Addendum to Concept Water Cycle Management Strategy

MP06_0034

Proposed Tourist and Commercial Development Goodnight Island and Greenwell Point

P0601331JC11_v1
June 2009

Figure 1: Dynamic wet-weather storage volumes over 50 year simulation period with no irrigation when storage tank is full.

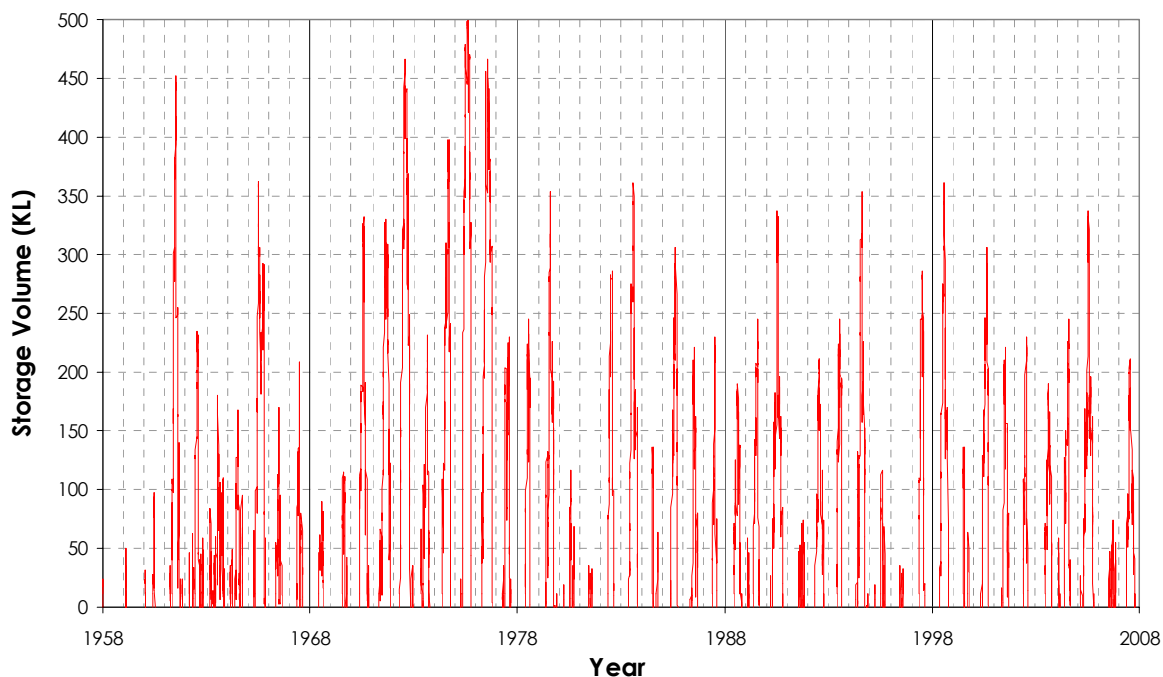
1. *'Provide clarification on effluent disposal area and wet weather storage size based on W&A amended hydraulic loading.*
2. *Prepare and operation and Maintenance Management Plan for the wastewater treatment plant and its disposal area.*

7. *Provide detailed treatment plant design and engineering details to achieve the desired effluent quality as detailed in Martens report.'*

We note that the wet-weather storage facility has been increased from 100 to 300 KL. Wet-weather storage modelling was reviewed on the basis of a 7000 m² sub-surface irrigation field. Results for the 50 year daily simulation are provided in Figure 1 where no irrigation occurred when the tank was full. The analysis clearly indicates the following:

1. For a 300 KL storage, maximum capacity is reached briefly 15 times in the 50 year historical record. During these periods, effluent is applied to the irrigation field (ie. 'over irrigation').

2. If no 'over irrigation' is undertaken, then the maximum storage volume reached is 500 KL.
3. Increasing the storage volume from 300 KL to 500 KL is not considered useful as there will be no realised environmental benefit by removing the very small amount of 'over-irrigation' potential from the irrigation system.
